Overview of NRC Monitoring Activities at the Saltstone Disposal Facility at the Savannah River Site

NRC Review Results

Alternate Conceptual Model for the SDF (Case K)

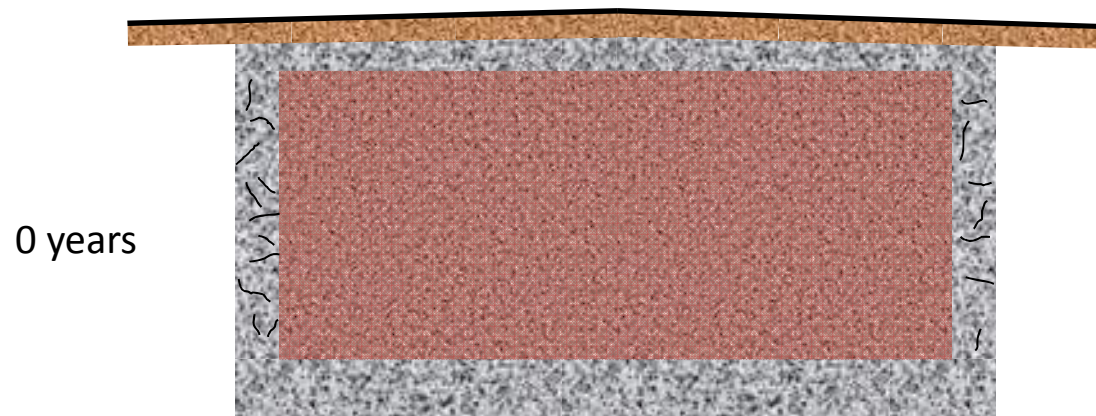
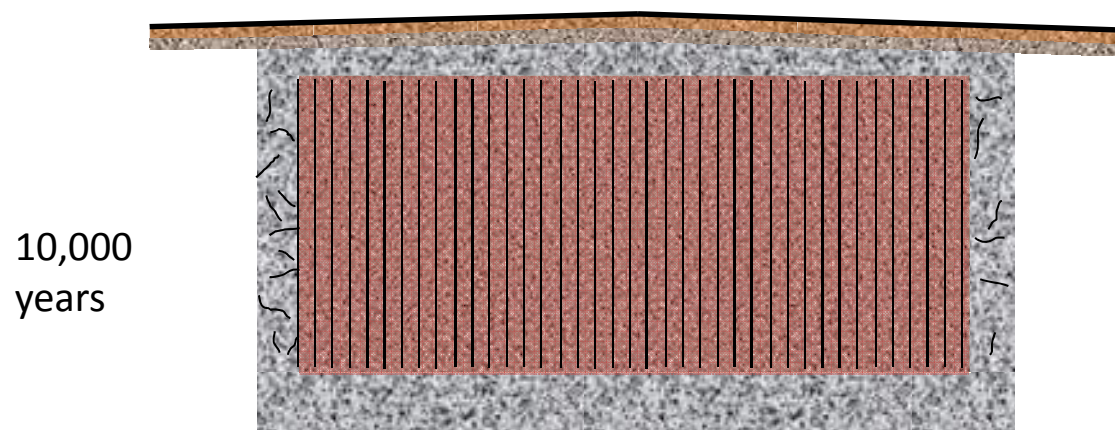
- Through-going fractures form every 10 cm in 10,000 years
- Oxidation proceeds from fracture faces and monolith edges
- Additional differences from Case A

SDF Time of Peak Dose Sensitivity to Fracturing

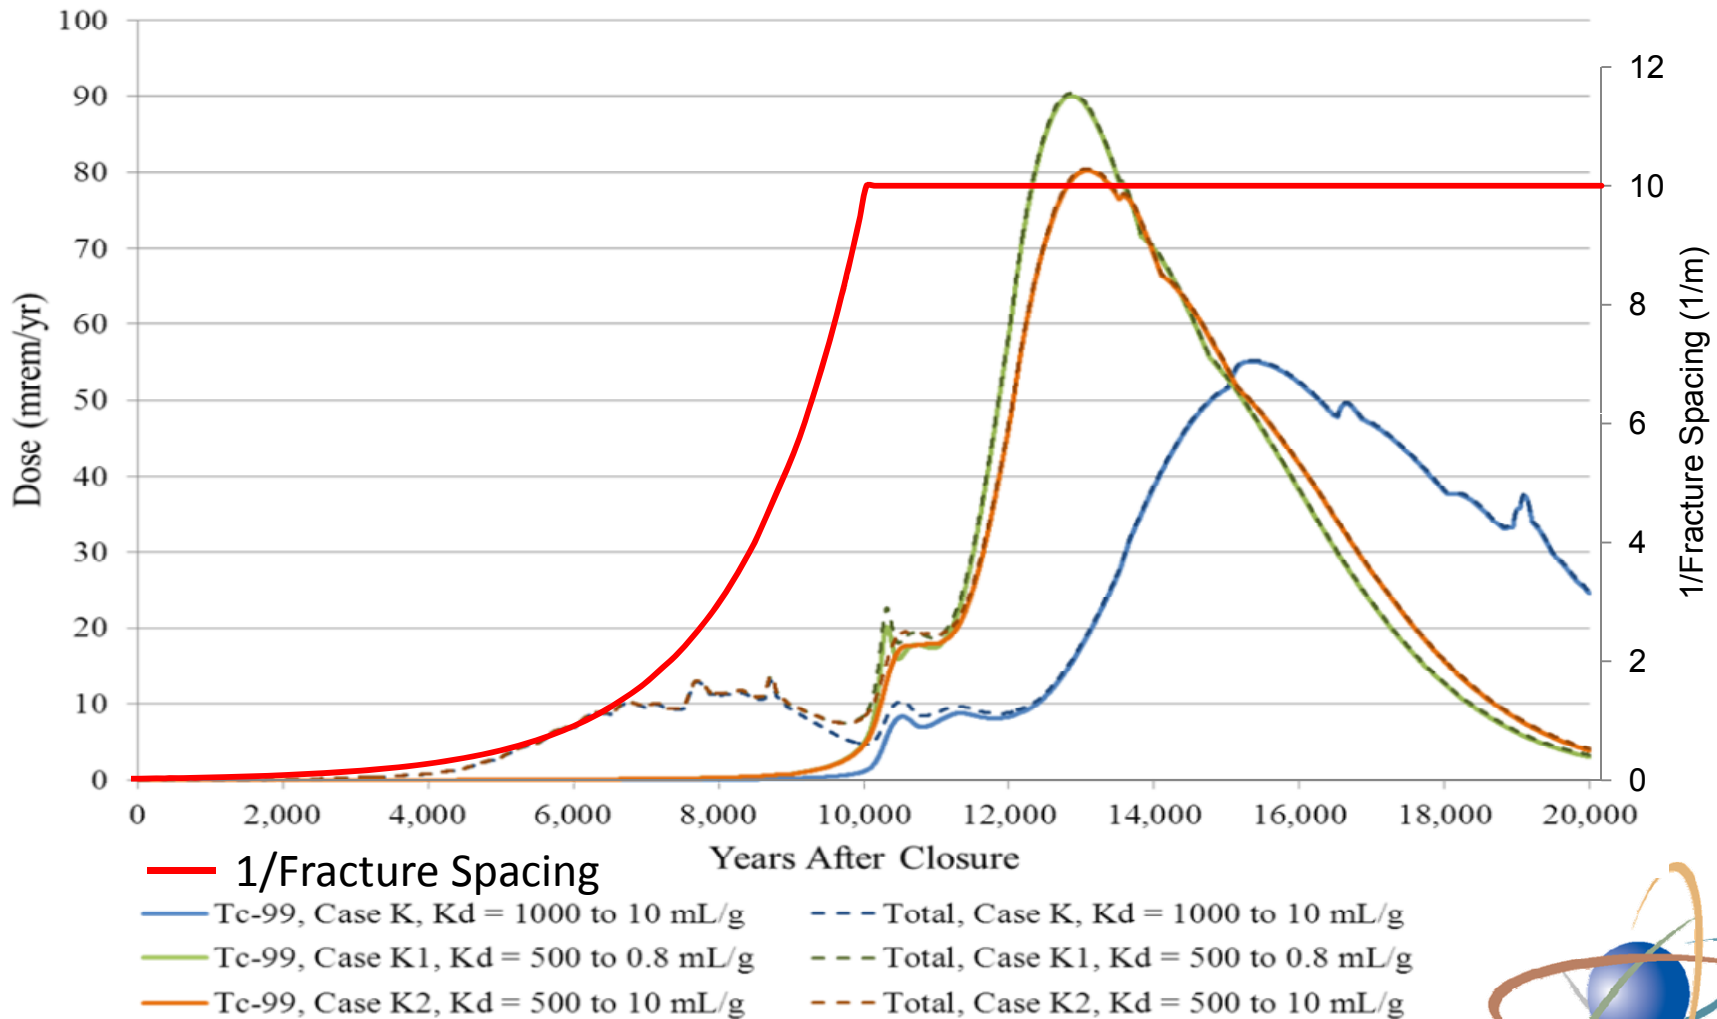
- DOE Case K, K1, and K2 peak doses greater than 25 mrem/yr after 10,000 years
- Peak timing sensitive to assumed fracturing
- Unexpected intermediate model results
- NRC sensitivity analyses used to evaluate implications of alternate assumptions related to unexpected intermediate results

Case K: DOE Intermediate Results

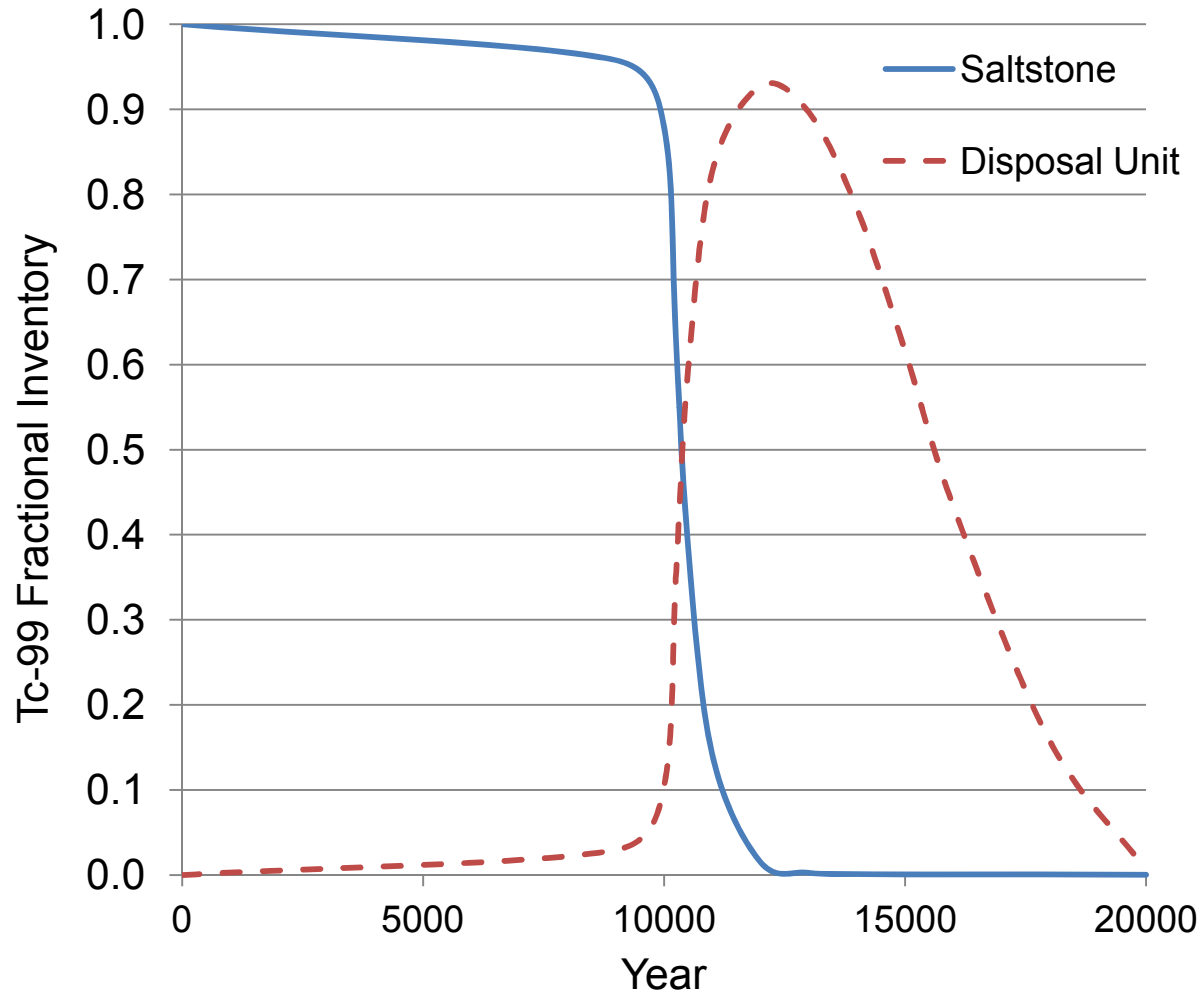
- Tc leaving saltstone nearly all retained in disposal unit concrete
- Reflects a 13X greater Tc concentration in disposal unit floor and walls than in original saltstone
- Unrealistic given material properties
- Significantly lowers predicted dose
